Access Compliance Report

Public Rights-of-Way

(Curb Ramps)

Intersection ID: N/A	Main Street: W_W_T_HARRIS_BV	Cross Street: N/A	Location: SW
ADA ID: C521695AC1C6	Ramp Type: PerpDiag	Initial Pass/Fail: Pass	Overall Compliance: No
Codes/Mitigation Info/Possible Solution		Field Measurements/Component Compliance

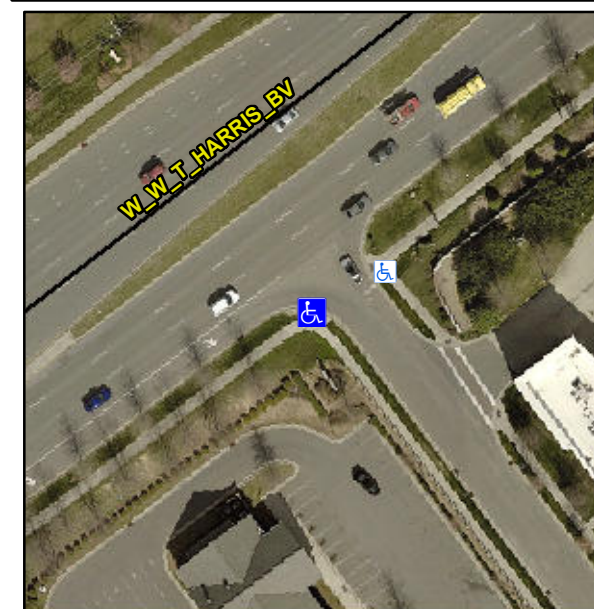
Not Found, R304.5.3, R304.2.2-Perp, R304.3.2-Para

Compliance	Description	Data	Compliance	Description	Data
N/A	Ramp Length (in)	57.0	Yes	Ramp Slope (%)	5.4
Yes	Ramp Width (in)	48.0	No	Ramp XSlope (%)	2.3
N/A	Flare Type LT	Sloped	N/A	Flare Type RT	N/A
N/A	Flare Slope LT (%)	6.3	N/A	Flare Slope RT (%)	1.6
N/A	Flare Traversable LT?	No	N/A	Flare Traversable RT?	No
Yes	Landing Length (in)	66.0	Yes	DWS Provided?	Yes
Yes	Landing Width (in)	48.0	Yes	DWS Contrast?	Yes
No	Landing Slope (%)	2.3	Yes	DWS Length (in)	24.0
No	Landing X Slope (%)	4.1	Yes	DWS Full Width?	Yes
N/A	Landing Curb? (Y/N)	No	Yes	DWS Offset (in)	1.0
N/A	Shared Landing?	No			
Yes	Gutter Ponding?	No	Yes	Gutter Slope (%)	4.3
Yes	Gutter Lip Ht (in)	0.0	Yes	Gutter X Slope (%)	0.1
N/A	Painted X Walk1?	No	N/A	Painted X Walk2?	No
	X Walk 1 Direction	To E		X Walk 2 Direction	To N
N/A	X Walk 1 Width (in)	N/A	N/A	X Walk 2 Width (in)	N/A
	X Walk 1 Slope (%)	0.4		X Walk 2 Slope (%)	2.1
	X Walk 1 X Slope (%)	1.5		X Walk 2 X Slope (%)	1.3

Remove & Replace Curb Ramp With Two New Directional Ramps or Equivalent.
